NC STATE UNIVERSITY CATES AVENUE MASTER PLAN

July 16, 2010

- 5. Appendix** **72**
 - June 28 Design Review Comments 72

Project Name: Cates Avenue Master Plan Study

SHUTTLE ROUTES

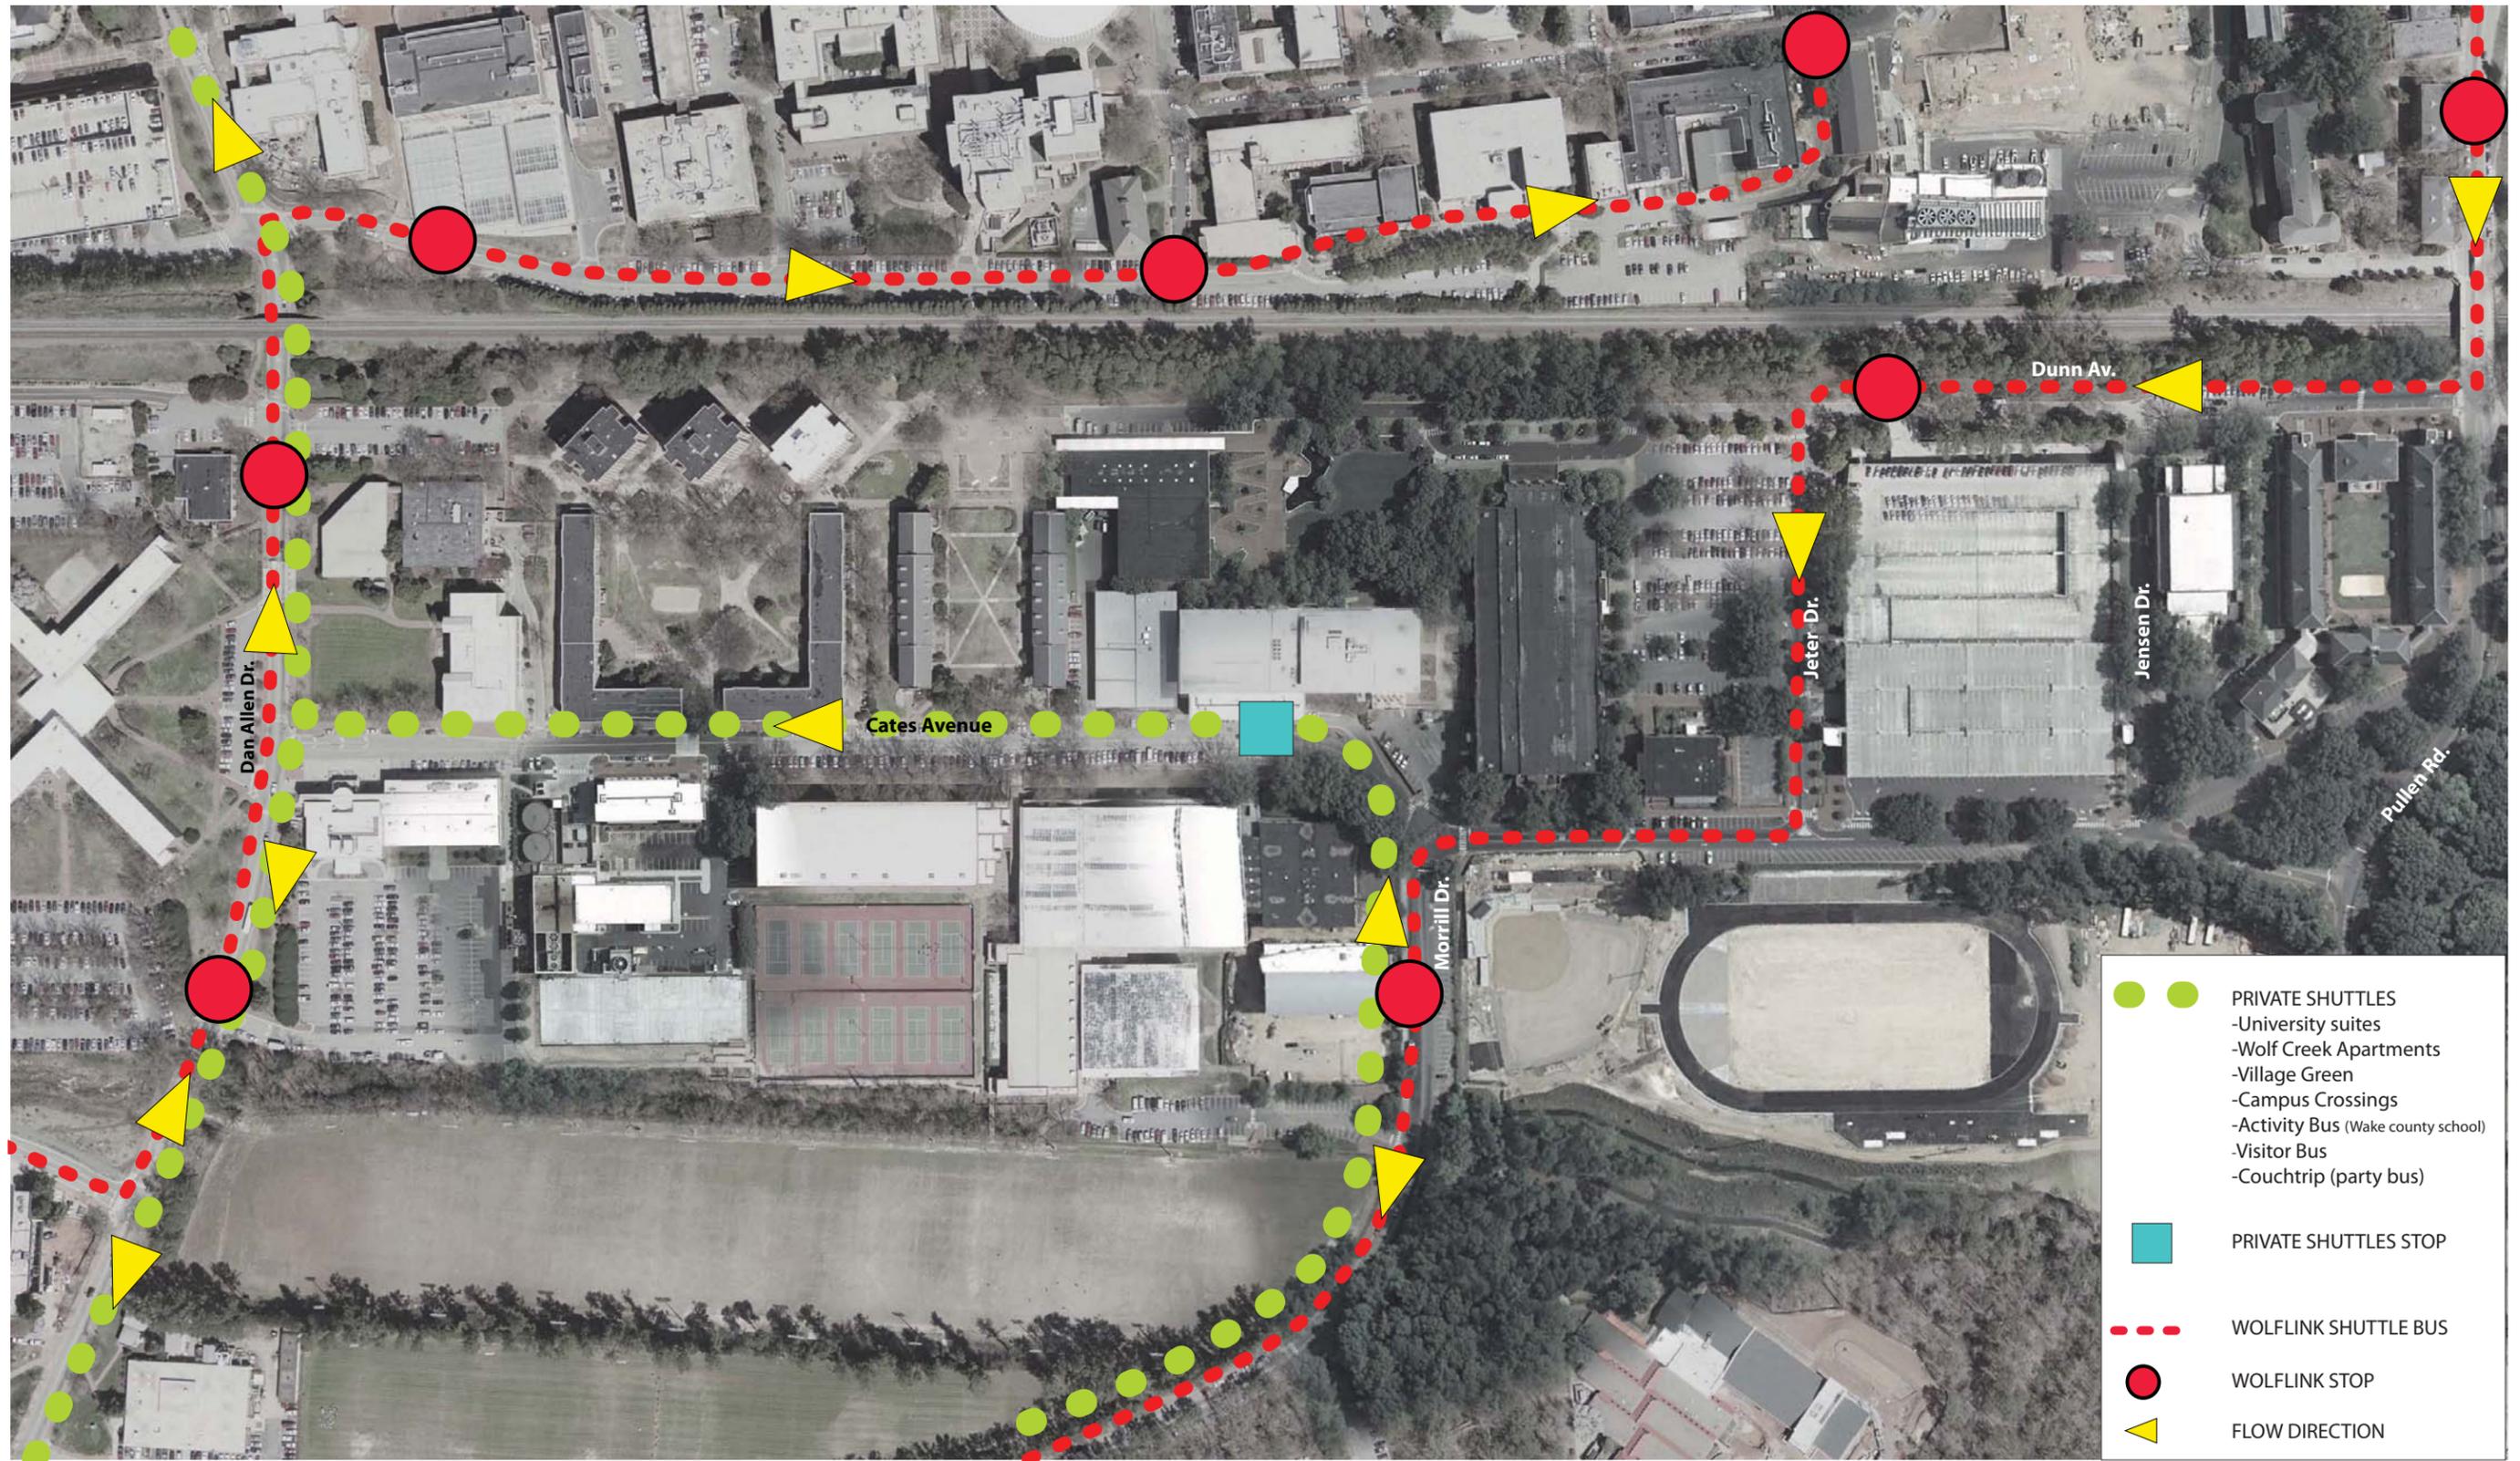
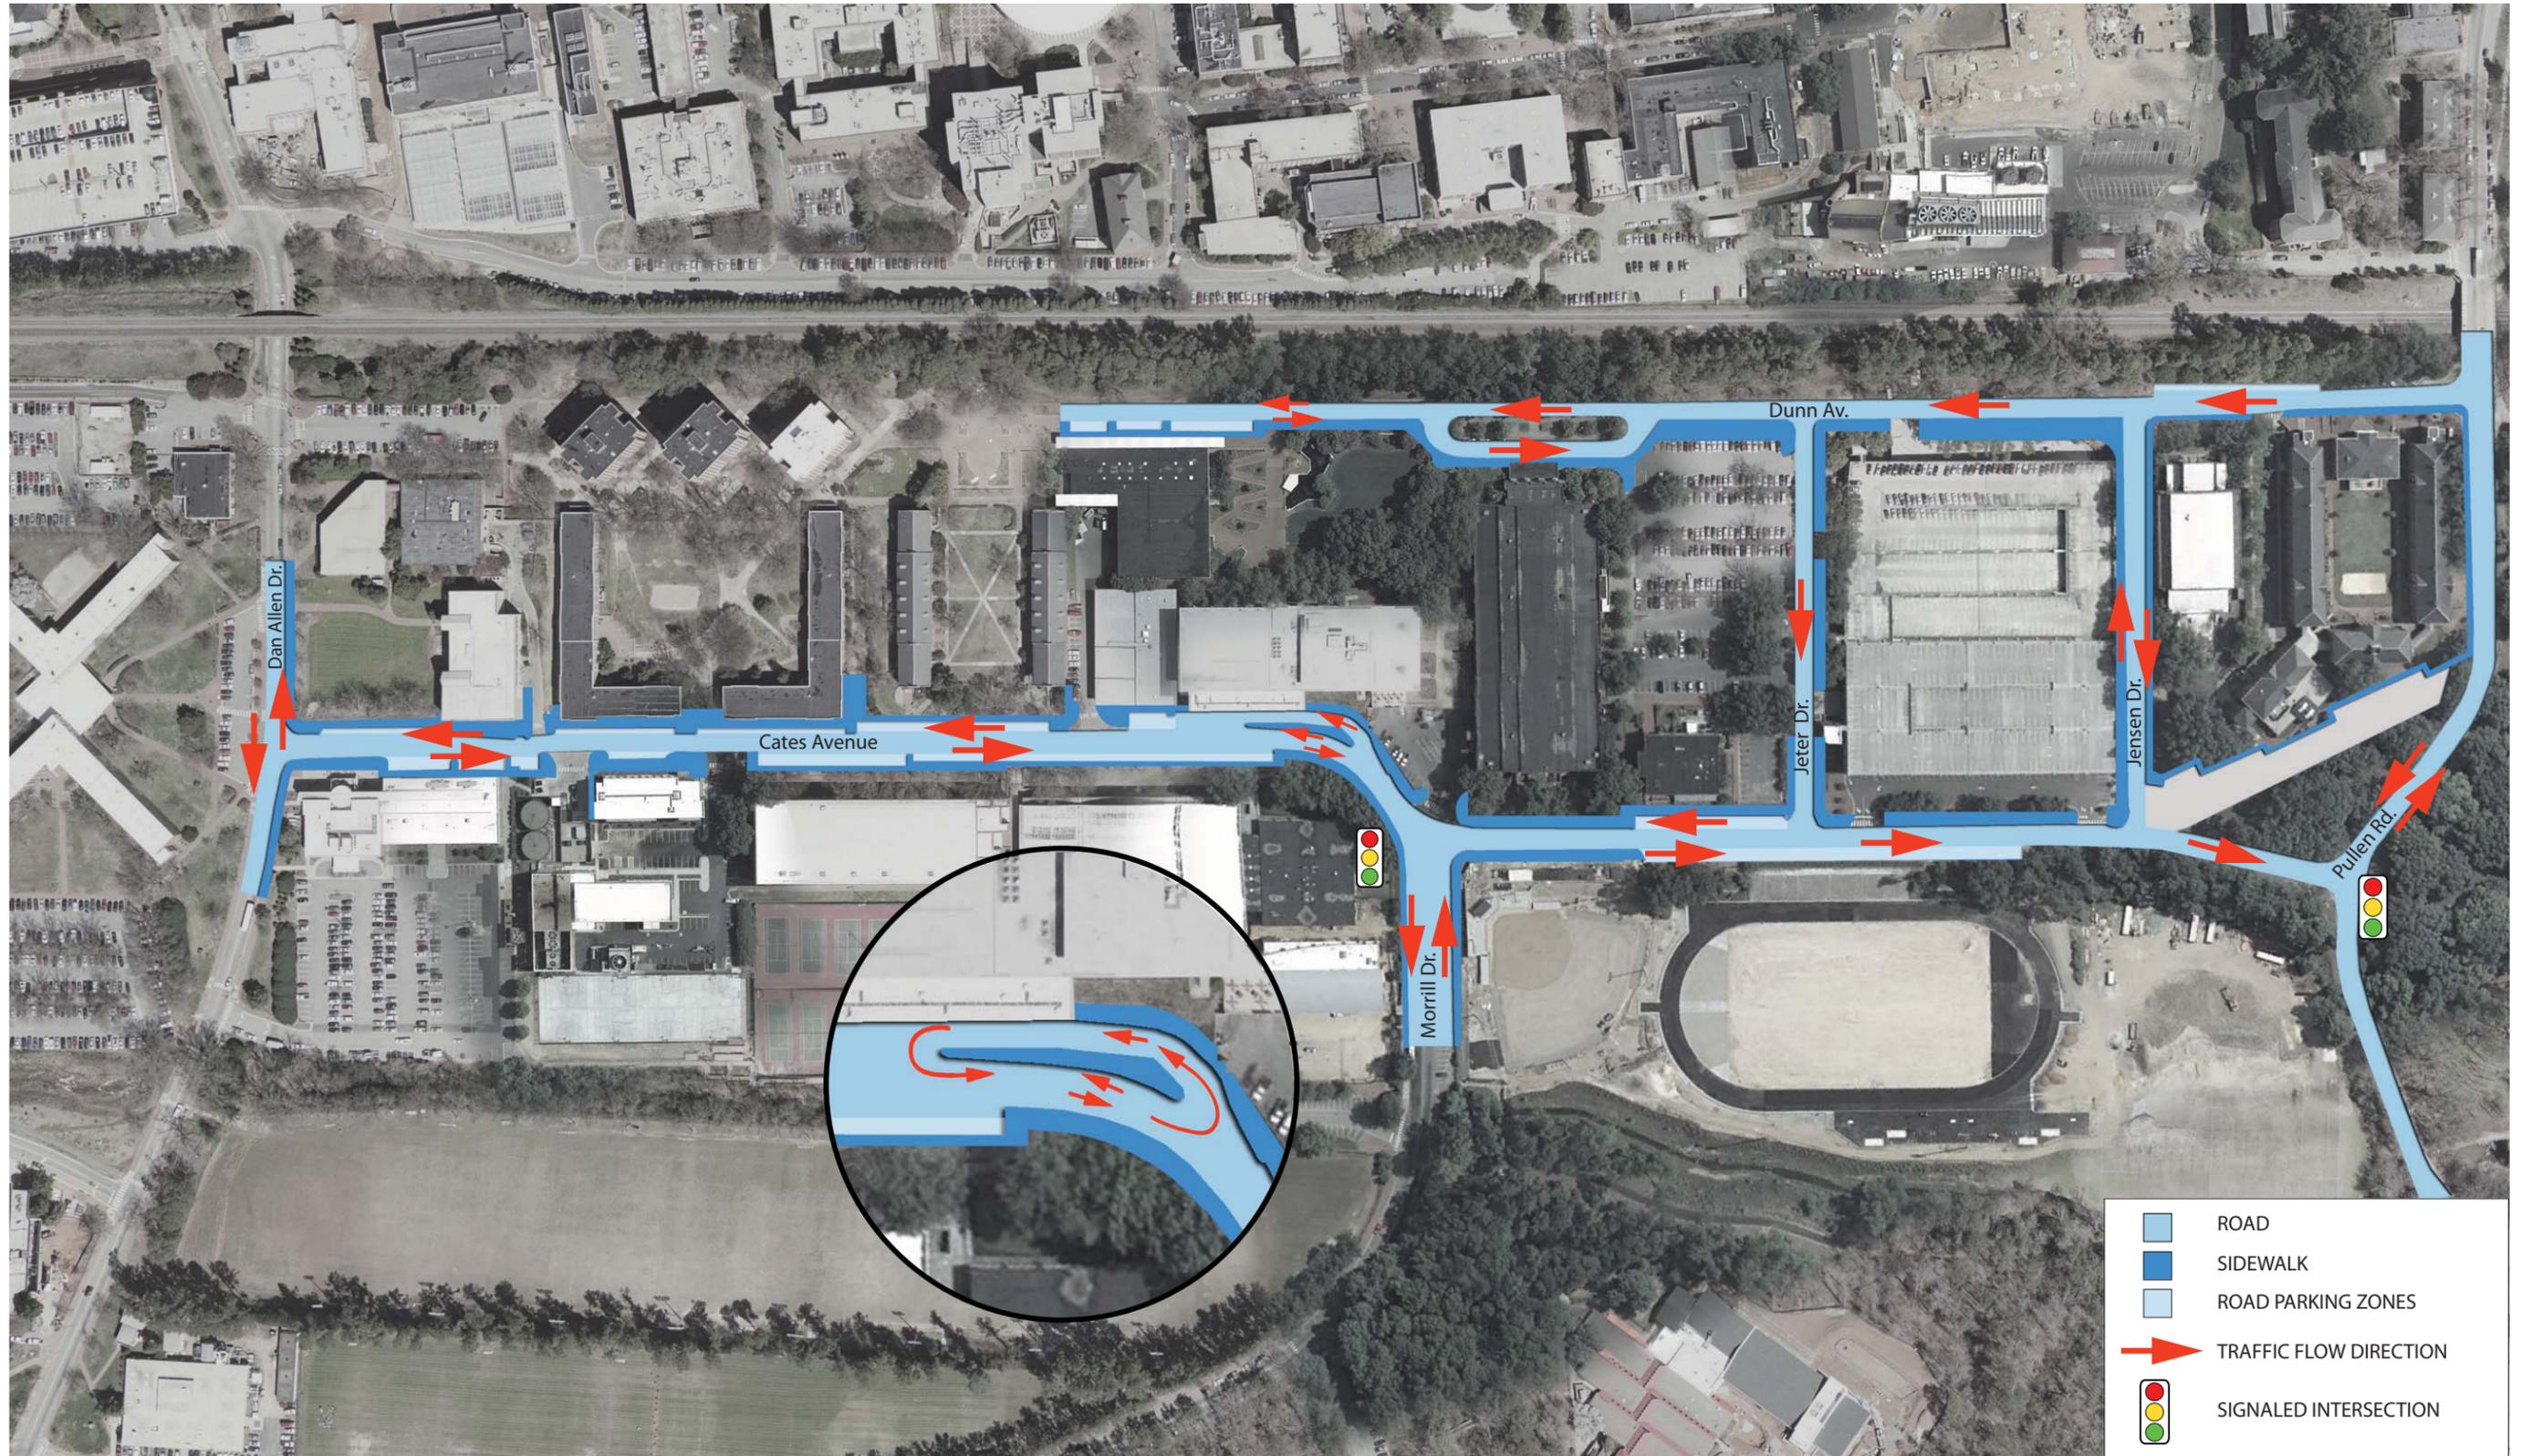
1. Pg 11 – The shuttle route flow path at the intersection of Dan Allen Dr. and Cates Ave. shows the flow going northbound on Dan Allen Dr. I do not know the exact percentage, but if I had to guess, I would say that the majority of the shuttle traffic goes southbound on Dan Allen Dr. towards Western Blvd.	1. Document is amended to reflect comment. The design team based the private shuttle route diagram on observation and on-site interviews with students and operators. The design team has not identified the origin or destination of these private shuttles beyond Cates Avenue. Future traffic study should include an analysis of these private shuttle routes.
